GTE AUTOMATIC ELECTRIC  
TYPE 101-A DIRECTOR SYSTEM  
FUNCTIONAL SCHEMATICS

1.01 This addendum is being reissued to make additional changes in Section 240-205-040, Issue 1. In ink or red pencil, make the changes as indicated in Part 2. In the margin adjacent to these changes, write "See Addendum".

Figure 20. "O" CLR Call, Code Field Programming.

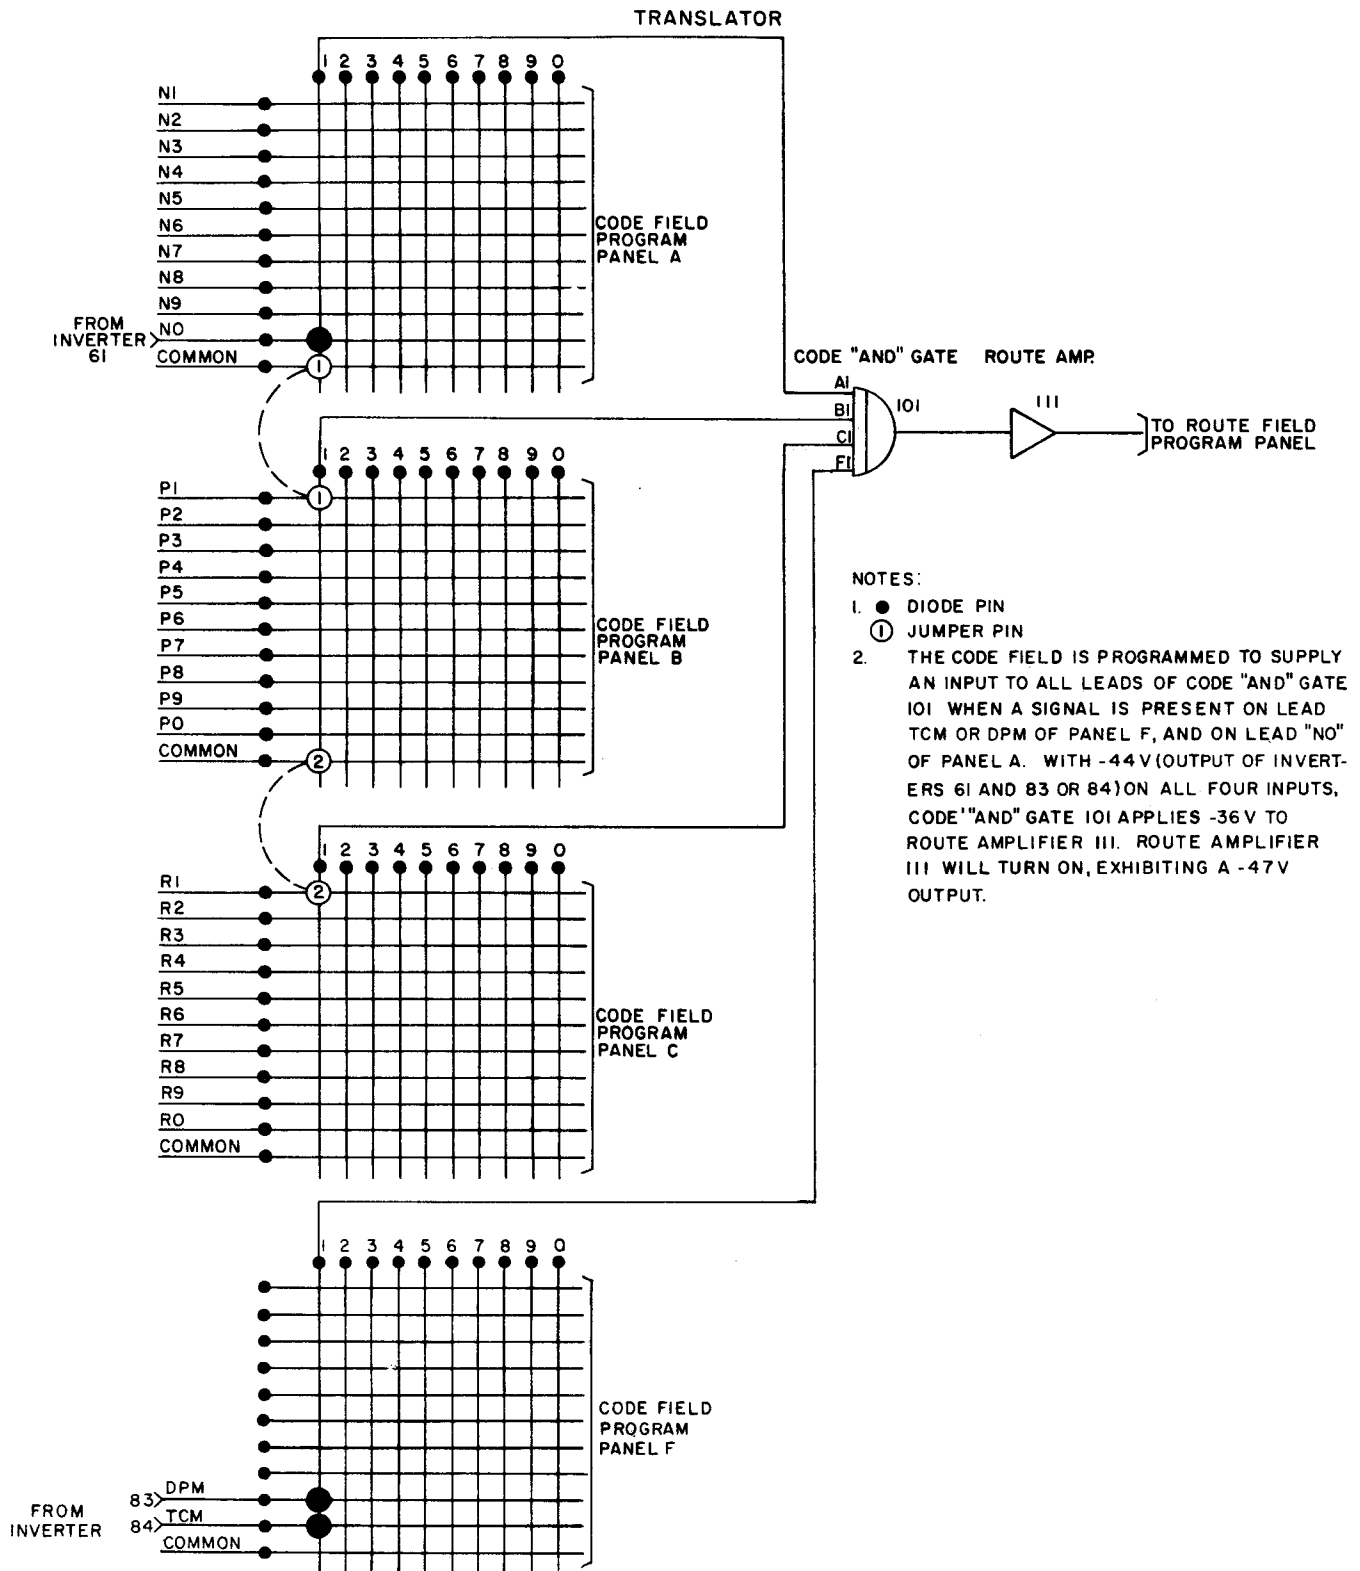
2.02 On page 25, cross out Figure 20. The new Figure 20 includes the class-of-service code field program panel F, and replaces the three input "AND" gate with a four input "AND" gate.
